RE: PLUS review – PLUS 2008-09-12; Village Brooke West

This document represents our written response to comments received. Our response to each State agency comment is given in red and introduced into the body of the original letter below.

PLUS – 2008-09-12
Village Brooke West

Figure 1: NRCS soil survey mapping in the immediate vicinity of Village Brook West

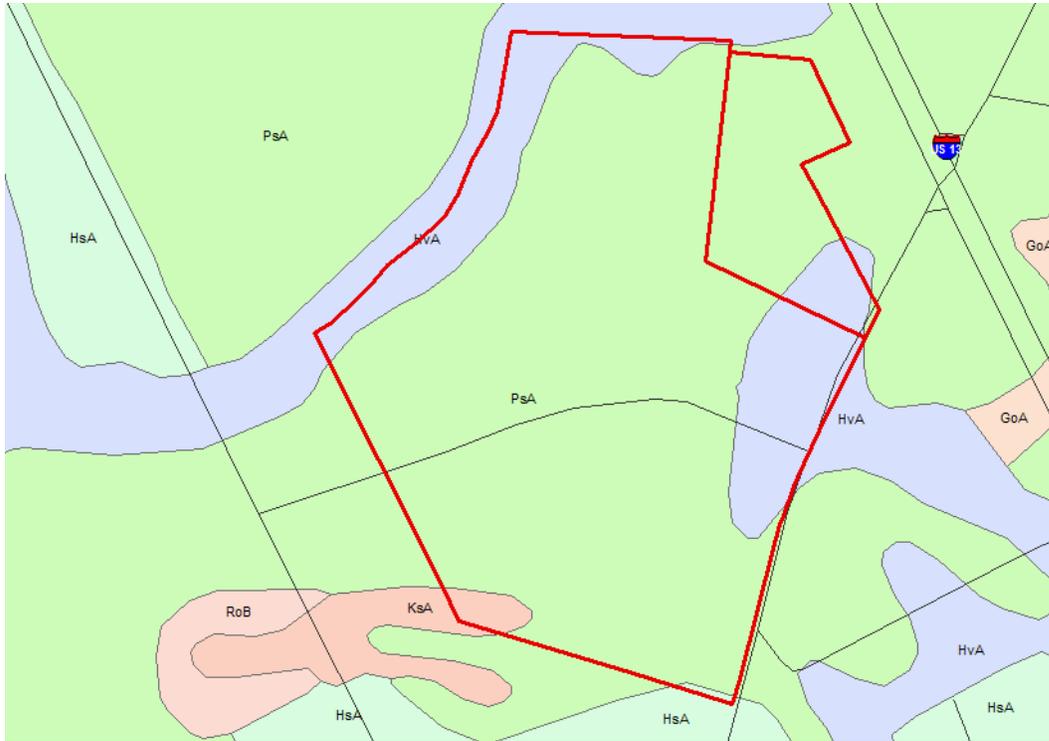
According to the NRCS soil survey update, Pepperbox-Rosedale complex (PsA), Klej (KsA), and Hurlock (HvA) were mapped in the immediate vicinity of the combined parcel project area (See figure 1). Pepperbox-Rosedale complex is a moderately well-drained to well-drained upland soil that has moderate to few limitations. Klej is a somewhat poorly-drained transitional soil (i.e., upland/wetland interface) likely to have both wetland and upland soil components. Hurlock is a poorly-drained wetland associated (hydric) soil that has severe limitations for development. Approximately 10 percent of the soils mapped on the combined parcel project area were mapped as

Hurlock. The Hurlock soils are generally associated with the mapped wetlands on the site which have not been proposed for development.

Additional unmapped wetlands are likely in the vicinity of the Hurlock soil mapping unit (See figure 1).

Figure 2: SWMP mapping in the immediate vicinity of Village Brooke West

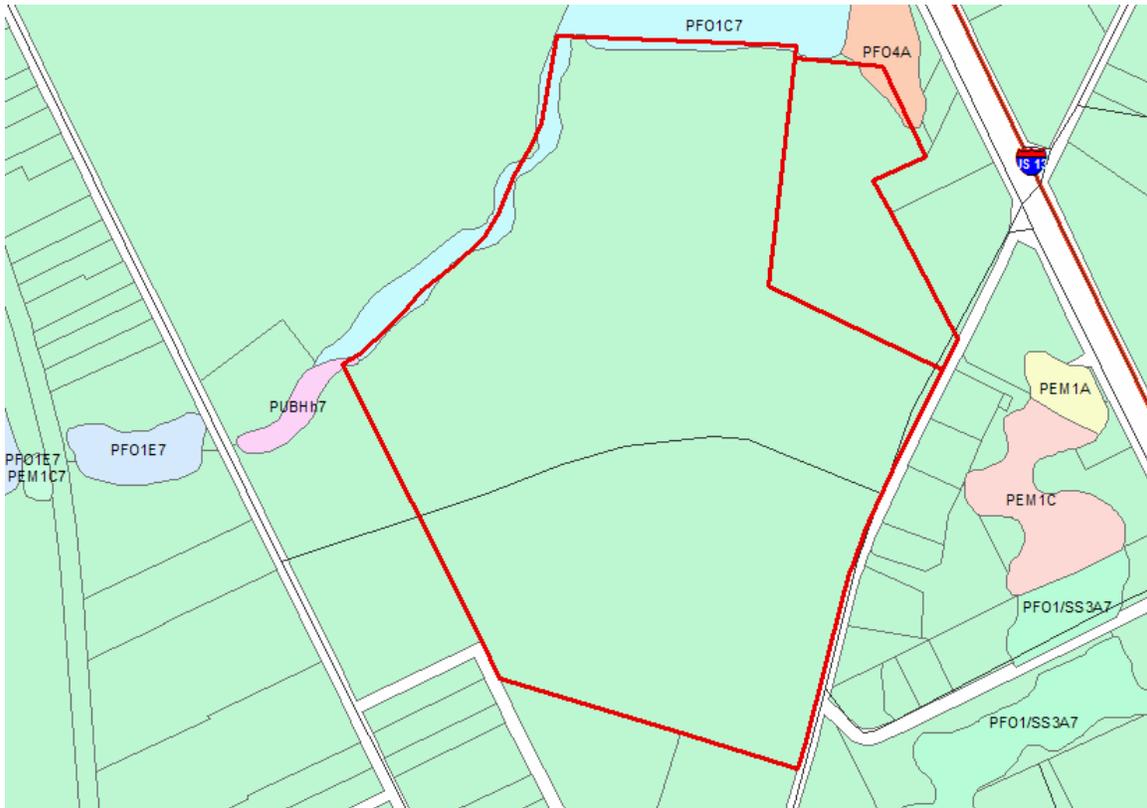
Based on Statewide Wetlands Mapping Project (SWMP) mapping, palustrine forested riparian wetlands (PFO1C7) and non-riparian palustrine wetlands (PFO4A), bound the entire northern and western boundaries of the proposed project area (See figure 2). The developer has retained JCM Environmental to field delineate the Federal jurisdictional wetlands on the site. The field delineation was surveyed by the project land surveyor and illustrated upon a Wetland Boundary Survey and upon the Preliminary Site Plan. All Federal jurisdictional wetlands identified have been avoided on the land use plan and not proposed for any form of development or disturbance.

A blue line stream flows along the northwest property boundary. Any work that is conducted in the stream may need a Subaqueous Lands Permit. Additionally, a vegetated buffer next to the stream may be required by the Town or County. **The stream was identified and accurately located by aerial topographic mapping during the early planning stages of the proposed development. The land use plan was prepared in such a manner as to avoid the need for any filling or disturbance to this stream.**

The State and Federal jurisdictional wetland area in its entirety will be left undisturbed before, during and after construction of this project. While a buffer of varying width is

allowed for in the current land use plan, the developer is unable to expand that buffer to the recommended 100' width and maintain residential densities that promote affordable housing pricing.
